SOUTH FLORIDA WATER
MANAGEMENT DISTRICT

Name: FL D.O.T. (S.R. 60 & Reedy Creek Bridge Replacement)

SURFACE WATER MANAGEMENT PERMIT NO. 49-00765-S

PROJECT DESCRIPTION: AUTHORIZATION FOR THE CONSTRUCTION AND OPERATION OF THE SURFACE WATER MANAGEMENT SYSTEM TO SERVE A 34.0 ACRE HIGHWAY PROJECT, DISCHARGING TO REEDY CREEK VIA REEDY CREEK SWAMP.
(NOTE: ORIGINAL PERMIT WAS ISSUED AS A CONCEPTUAL PERMIT DATED NOVEMBER 10, 1994)

GRADING PLAN
POND NO. 1

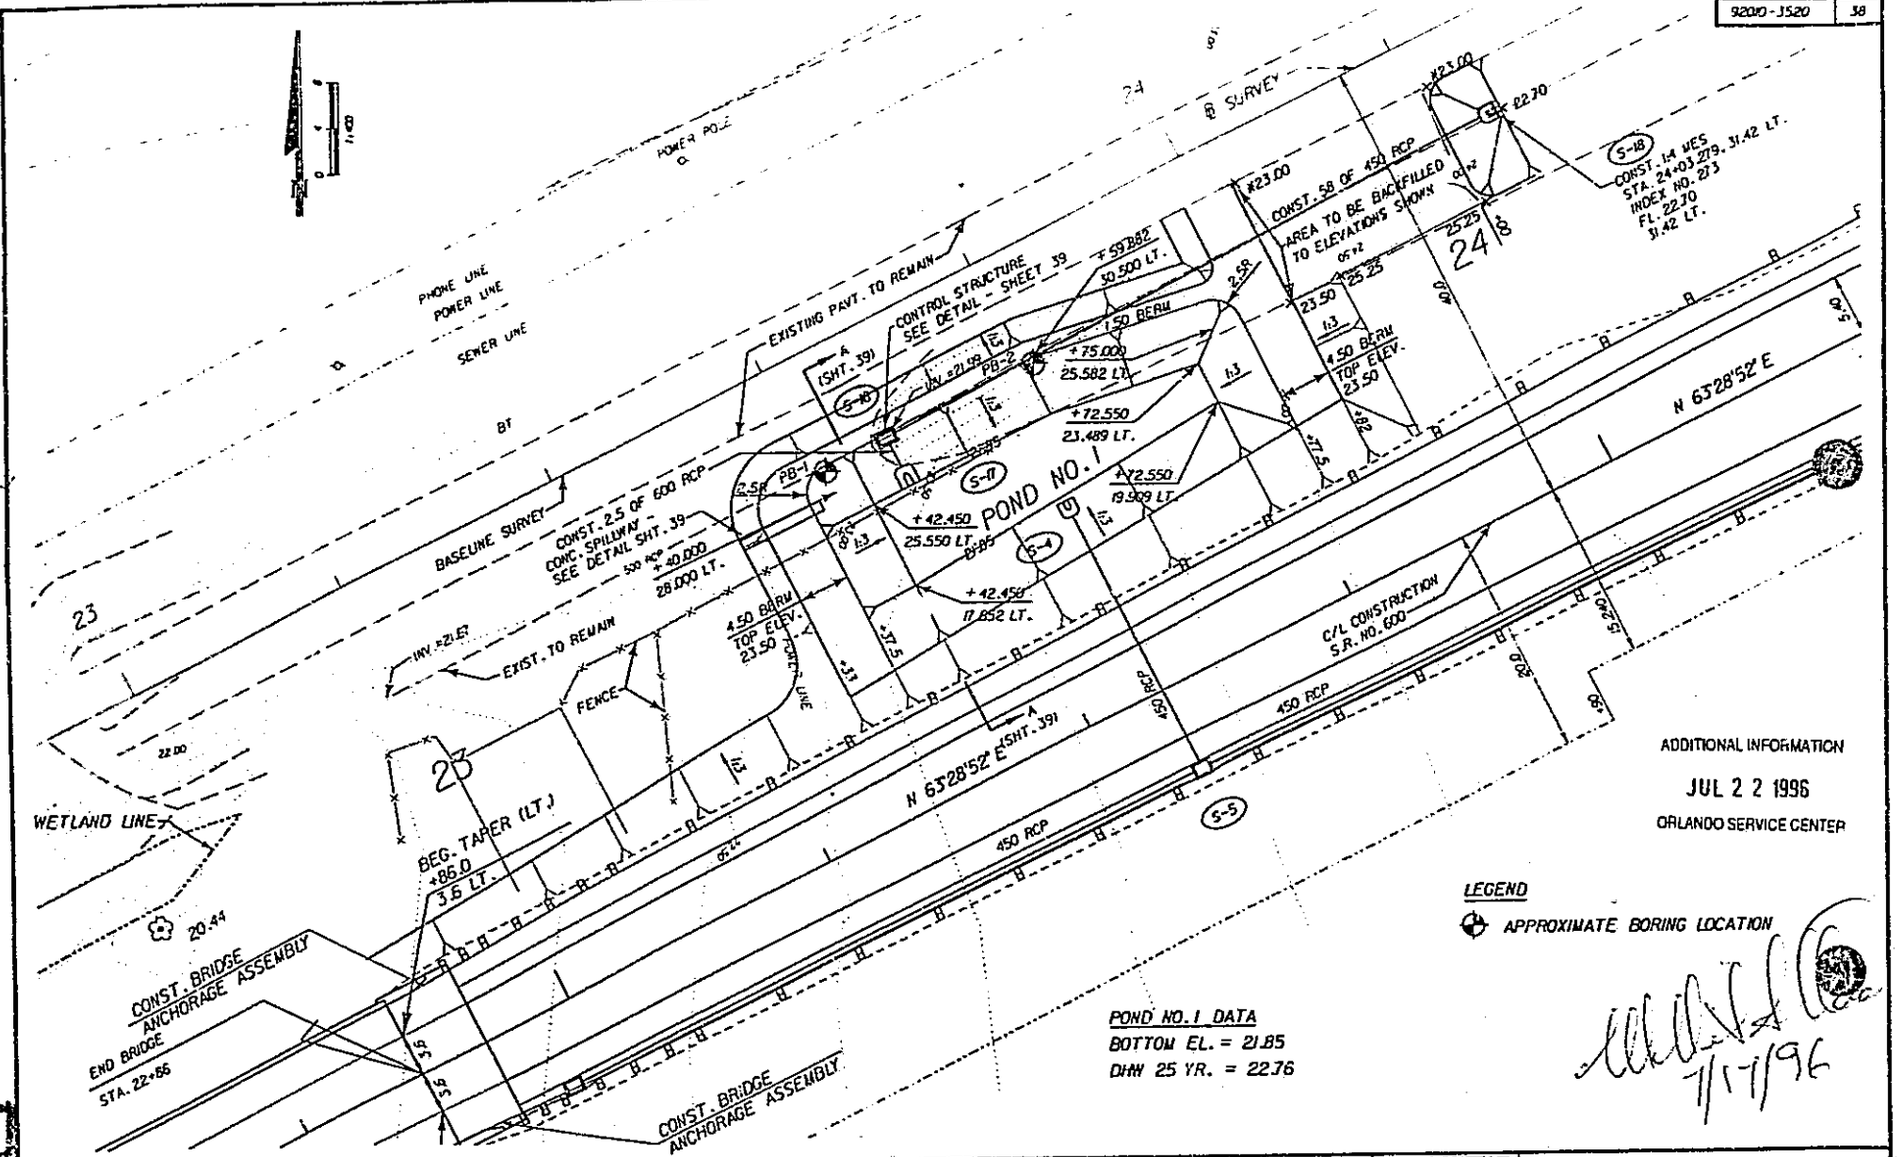
Sheet 38 - Grading Plan - Pond No. 1:

- The wetland impact areas have been identified with hatching.
- Turbidity and erosion control devices have been added and identified.

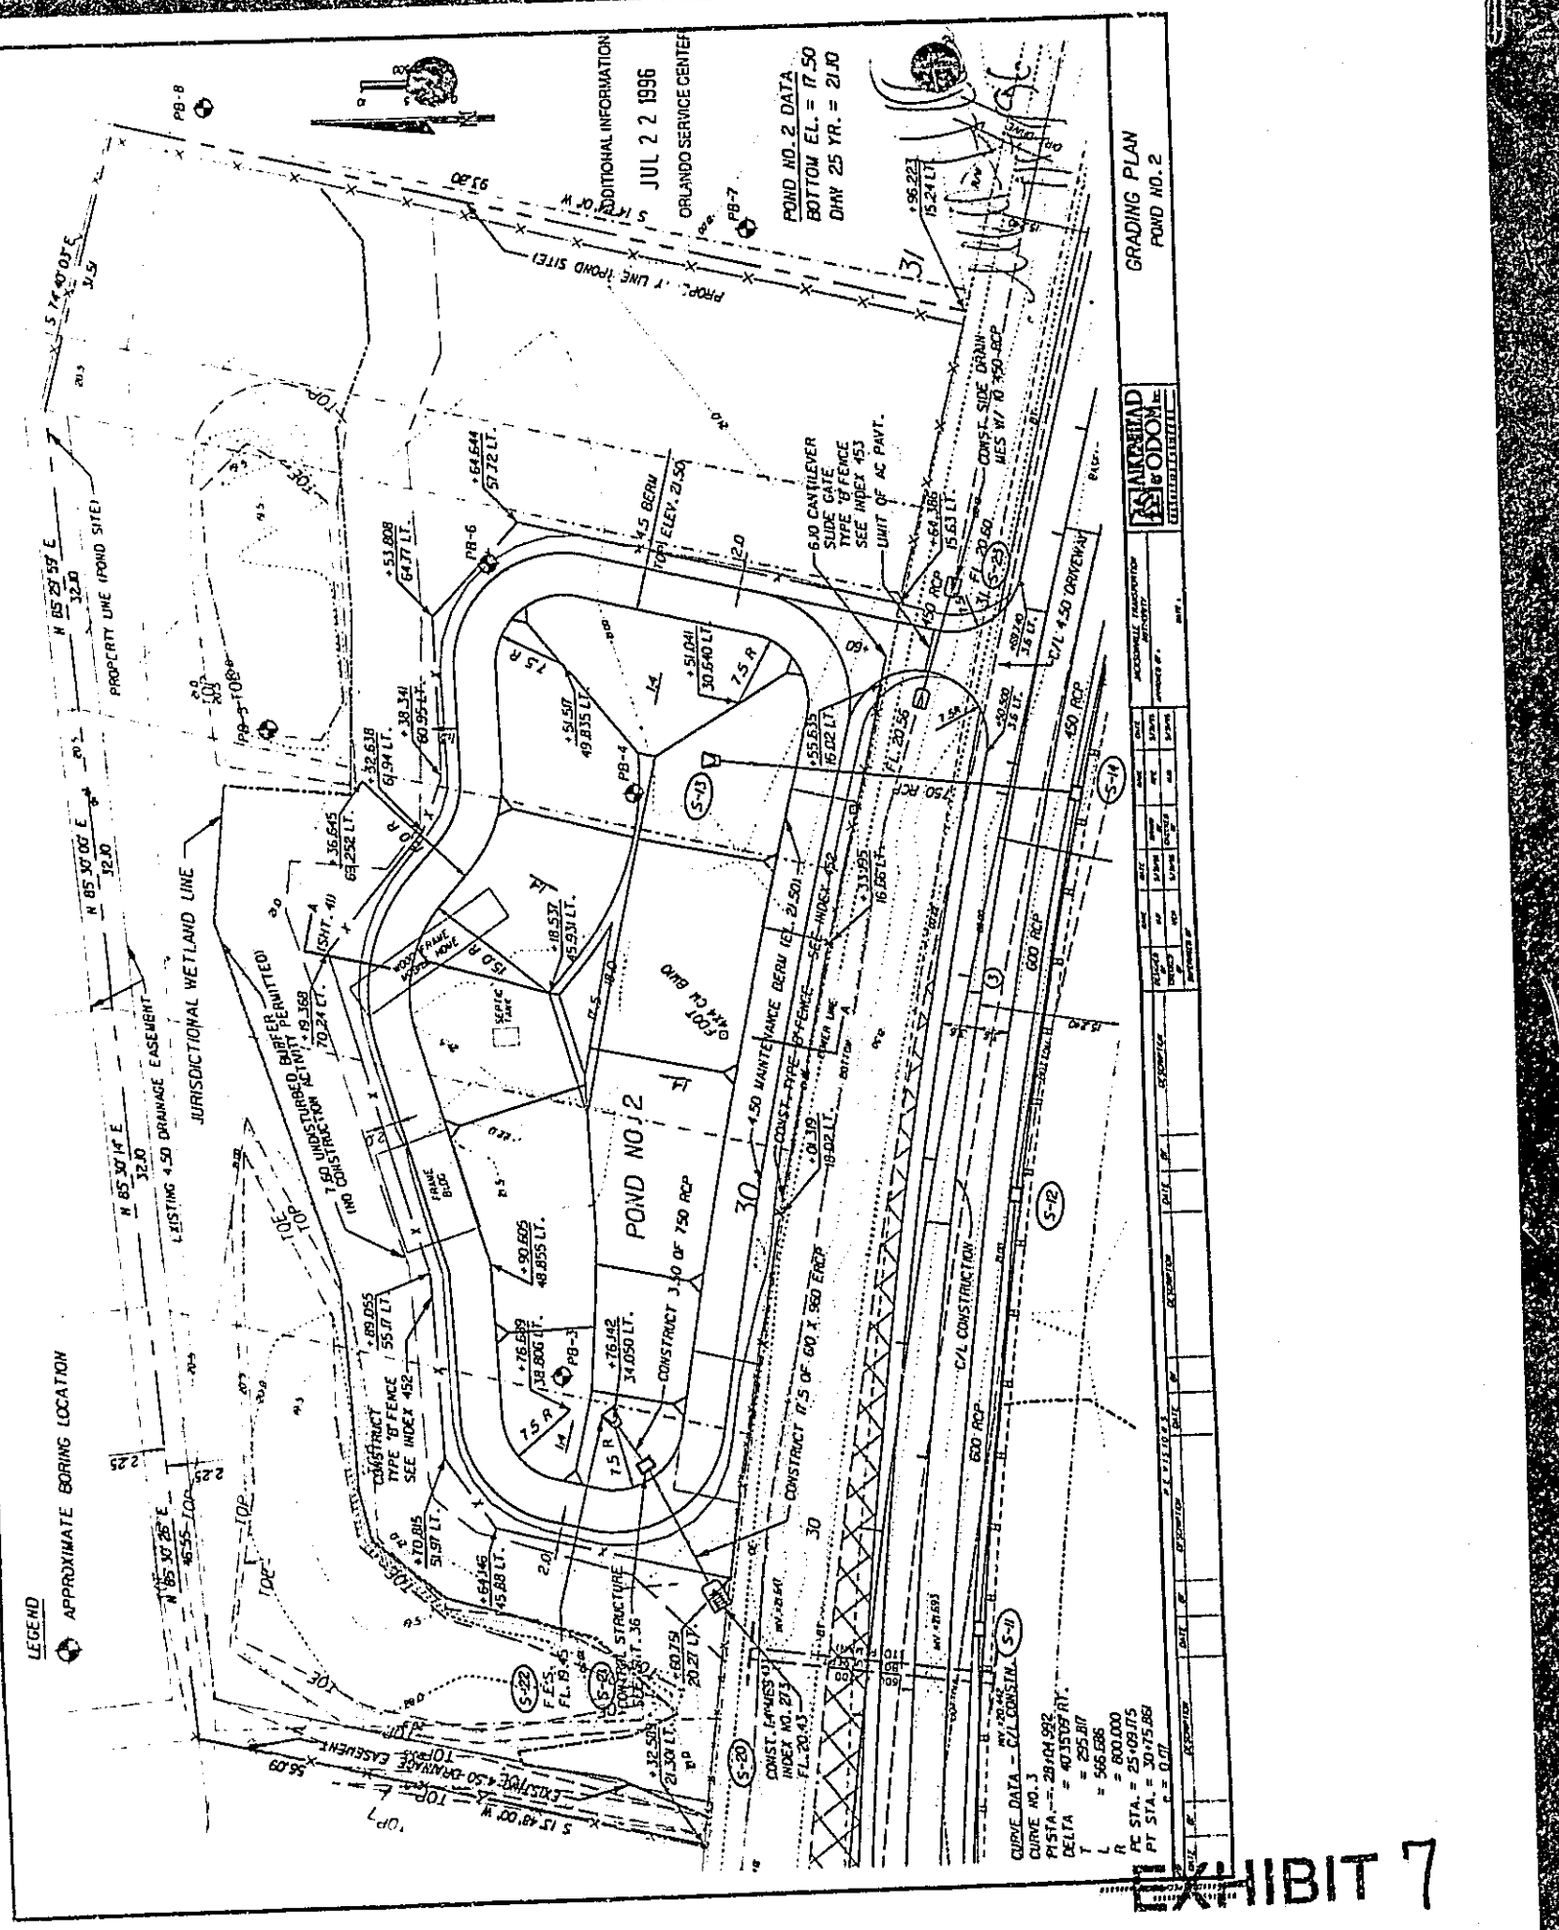
Sheet 40 - Grading Plan - Pond No. 2:

- The wetland impact areas have been identified with hatching.
- The limit of construction in the wetland area has been identified.
- Turbidity and erosion control devices have been added and identified.

WETLAND IMPACTS

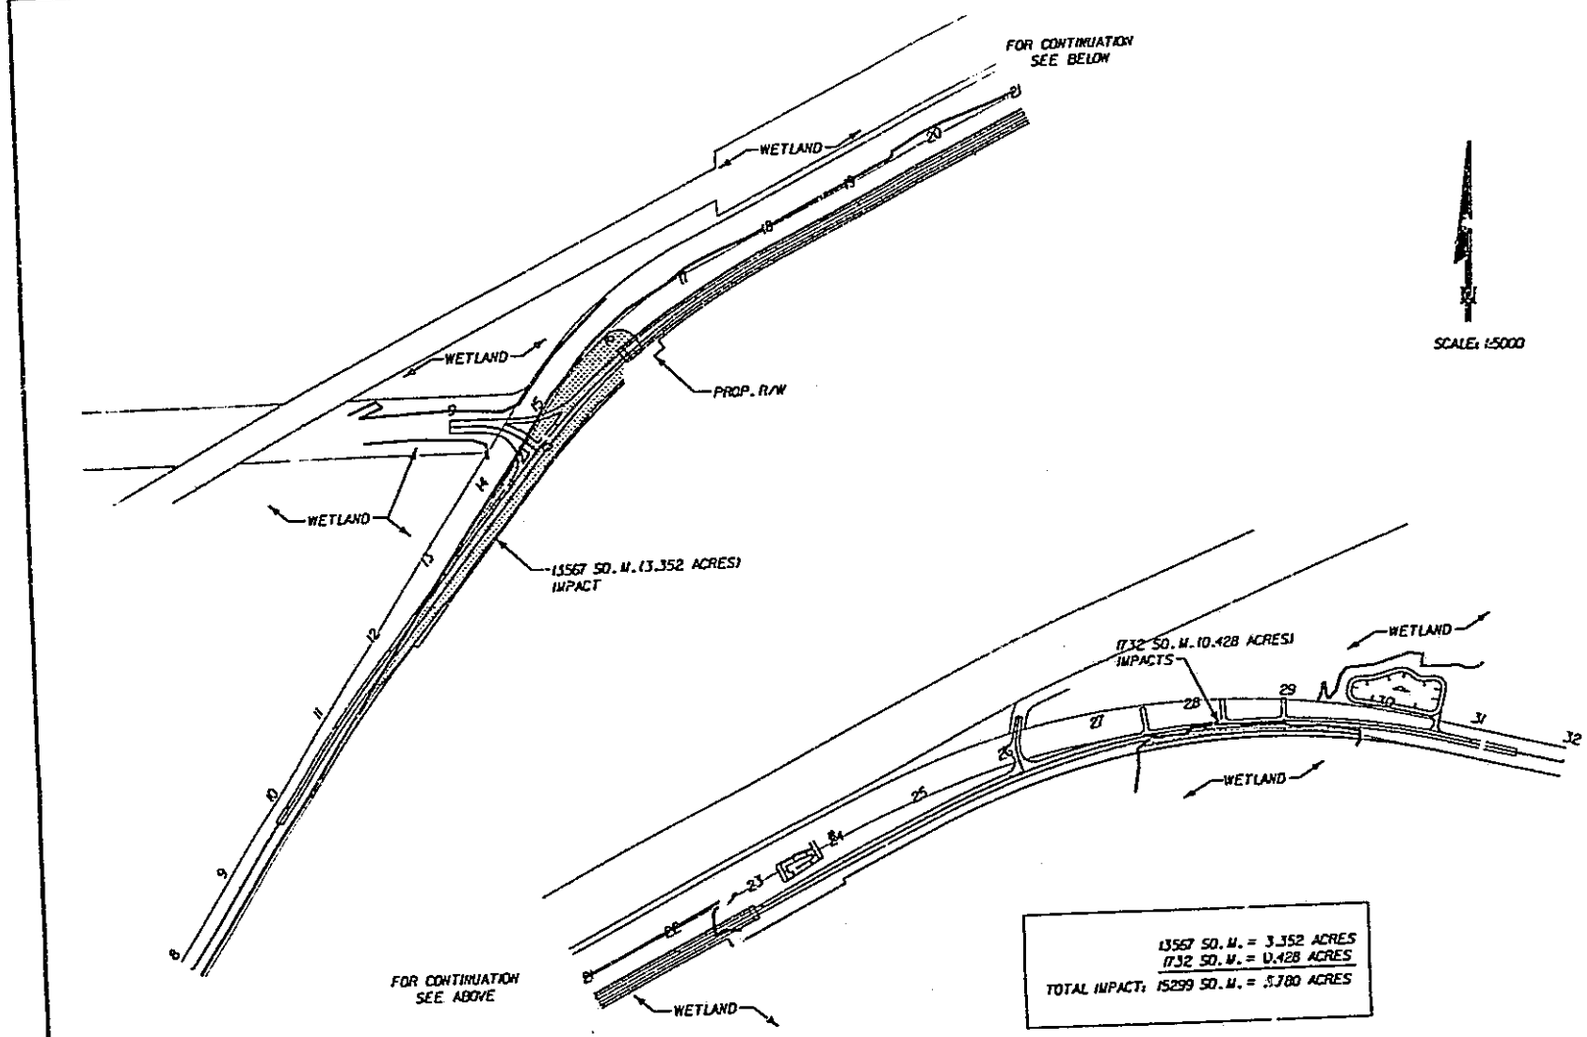
(a) Please revise the Plan & Profile and Sheet 98 portions of the construction plans to illustrate and label the impacts associated with the bridge (including the area of clearing). Please revise Sheet 98 to include an acreage figure in the label; and

2. There appears to be inconsistencies between Sheet 98 and the Plan and Profile portions of the construction plans. Please revise the Plan and Profile sheets to reflect the following information (as depicted on Sheet 98):

Sheet 98 - Wetland Impacts:

- The impacts associated with the bridge have been hatched, labeled, and the quantity added to the label.
